Access Compliance Report Public Rights-of-Way (Curb Ramps)

Main Street: CALM_CREEK_CIR		Cross Street: DAWNWOOD		Location:	NE
ADA ID: RPRK211025115118	Ramp Type: Type 4 - Parallel	Initial Pass/Fail: Fail	Overall Compliance: No	Severity Score:	15
Codes/Mitigation Info/Possible Solution			Field Measurements/Component Compliance

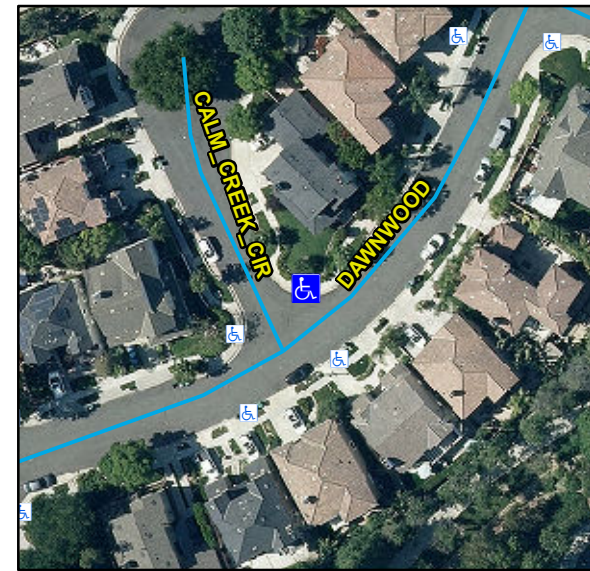
Compliance	Description	Data	Compliance	Description	Data
N/A	Ramp Length LT (in)	107	N/A	Ramp Length RT (in)	116
Yes	Ramp Width LT (in)	53	Yes	Ramp Width RT (in)	53
Yes	Ramp Run Slope LT (%)	1.9	No	Ramp Run Slope RT (%)	8.7
Yes	Ramp Cross Slope LT (%)	1.1	Yes	Ramp Cross Slope RT (%)	0.2
N/A	Landing Present	N/A	N/A	DWS Provided	N/A
N/A	Landing Length (in)	N/A	N/A	DWS Contrast	N/A
N/A	Landing Width (in)	N/A	N/A	DWS Length (in)	N/A
N/A	Landing Run Slope (%)	N/A	N/A	DWS Full Width	N/A
N/A	Landing Cross Slope (%)	N/A		DWS Offset Type	N/A
N/A	Landing Movement Obstructed?	N/A	N/A	DWS Offset Left (in)	N/A
	Landing Movement Type	N/A	N/A	DWS Offset Right (in)	N/A
N/A	Landing Shared	N/A			
N/A	Clear Space	Yes			
N/A	Clear Space To Crosswalk (in)	N/A			
N/A	Marked Crosswalk 1	No	N/A	Marked Crosswalk 2	No
	Crossing 1 Direction	W		Crossing 2 Direction	S
	Marked Crosswalk 1 Width (in)	N/A		Marked Crosswalk 2 Width (in)	N/A

Remove & Replace Curb Ramp With Two New Directional Ramps or Equivalent.
